Technical Service Bulletin

GROUP	NUMBER
BODY ELECTRICAL	25-BE-017G
DATE	MODEL(S)
DECEMBER 2025	GV80 (JX1) GV80 COUPE (JX1)

SUBJECT: INOPERABLE HORN REPLACEMENT

Description: Some GV80 (JX1) vehicles may have an inoperable horn due to exposure to moisture from the horizontal mounting position. This bulletin provides instructions to replace and vertically mount the horns.

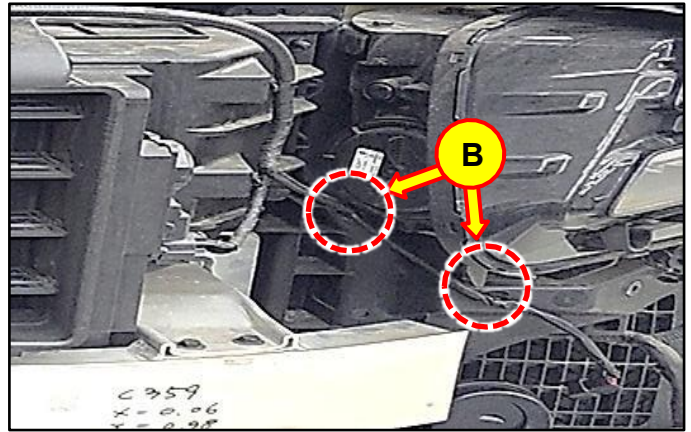
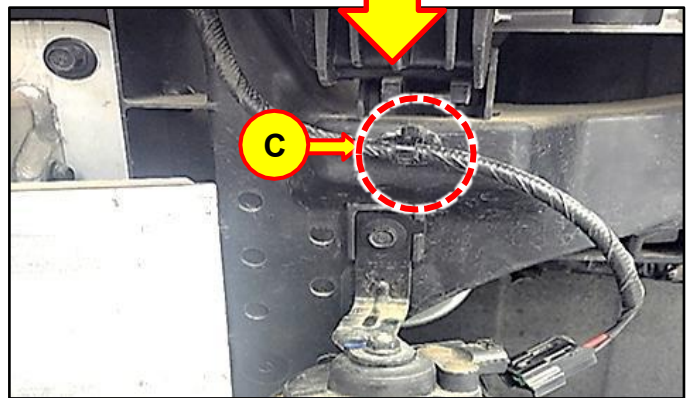
- Cut the 2 LH horn wiring cable ties (B).

- Measure **7.9 inches (200 mm)** from the horn connector then secure the wiring using a new cable tie at the designated location (C).

Securing wiring **7.9 inches (200 mm)** from the horn connector ensures proper length and prevents tension to wiring harness.

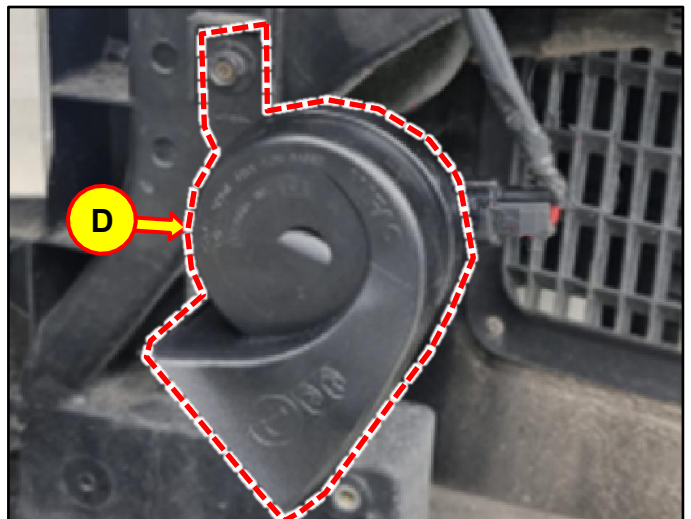
- Install the new LH horn (D) and connect to the horn connector.

The supplied horn will be **VERTICALLY MOUNTED**.

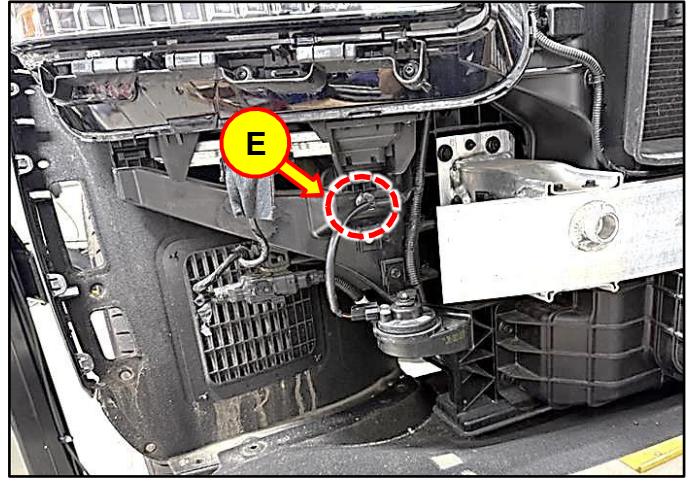
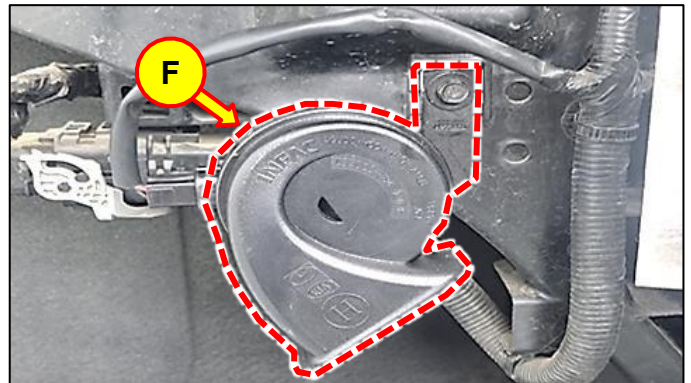
- Cut the RH horn wiring cable tie (E).

- Install the new RH horn (F) and connect to the horn connector.

The supplied horn will be **VERTICALLY MOUNTED**.

RH horn wiring can be free as it will not interfere with other parts.
